<b>Well Name:</b> SHANGHAI ROOSTER 15-3 FED	<b>Well Location:</b> T25S / R29E / SEC 15 / SESW / 32.123563 / -103.97406	<b>County or Parish/State:</b> EDDY / NM
<b>Well Number:</b> 124H	<b>Type of Well:</b> OIL WELL	<b>Allottee or Tribe Name:</b>
<b>Lease Number:</b> NMNM014778, NMNM14778	<b>Unit or CA Name:</b>	<b>Unit or CA Number:</b>
<b>US Well Number:</b> 3001550040	<b>Well Status:</b> Drilling Well	<b>Operator:</b> XTO ENERGY INCORPORATED

**Notice of Intent**

**Type of Action:** APD Change

## Shanghai Rooster 15-3 Fed 124H Sidetrack

Current WBD

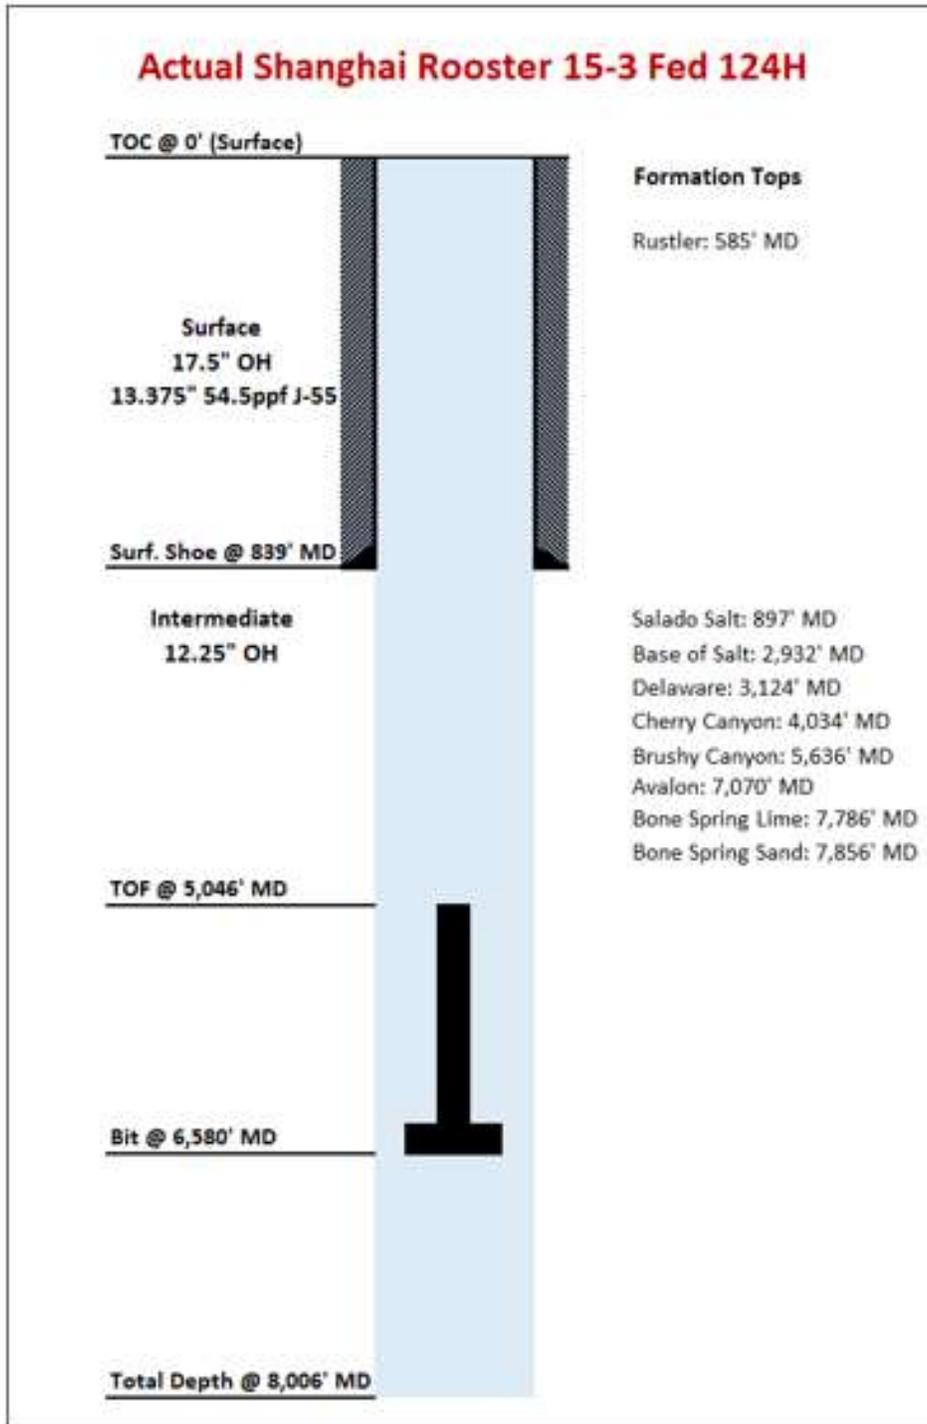
**Current Status:** XTO has set surface casing with cement to surface at 839' MD. Intermediate drilled to MD of 8006' MD. Fish stuck at 5046' to 6580' MD.

1. Surface: 17-1/2" hole at 854' MD, 13-3/8" csg @ 839' MD. Cemented w/Lead: 410sx 12.8ppg Cl C Cmt (1.78 yield) & Tail: 333sx 14.8ppg (1.35 yield). Circ to surf. 98 bbls returned to surface.
2. Intermediate: 12-1/4" hole @ 8006'
  1. Fish: 5046' to 6580' MD (12.25" Bit and drill string)

Shanghai Rooster 15-3 Fed 124 H  
Proposed WBD

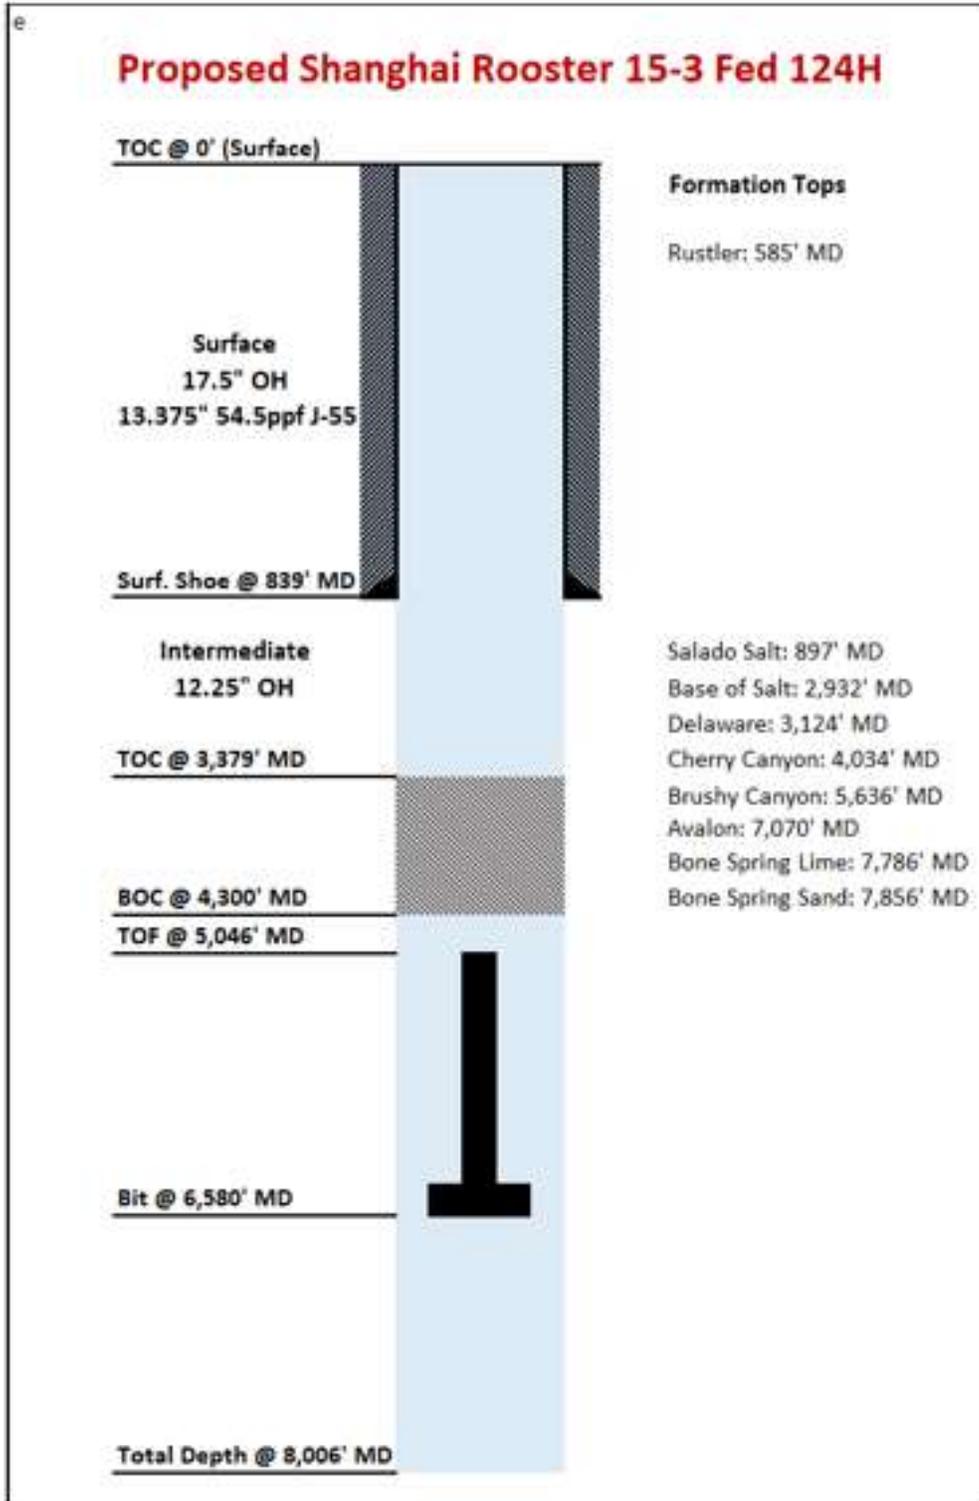
**Requested Proposal:** XTO proposes to set a 500' cement plug inside the 12.25" intermediate wellbore, sidetrack and redrill the 12-1/4" intermediate section.

1. Set 500' balance plug at 4300' MD, 400 sx Class H 17.0 ppg
2. RIH with 12.25" Intermediate sidetrack BHA
3. Drill to original planned intermediate TD of 8006' MD.
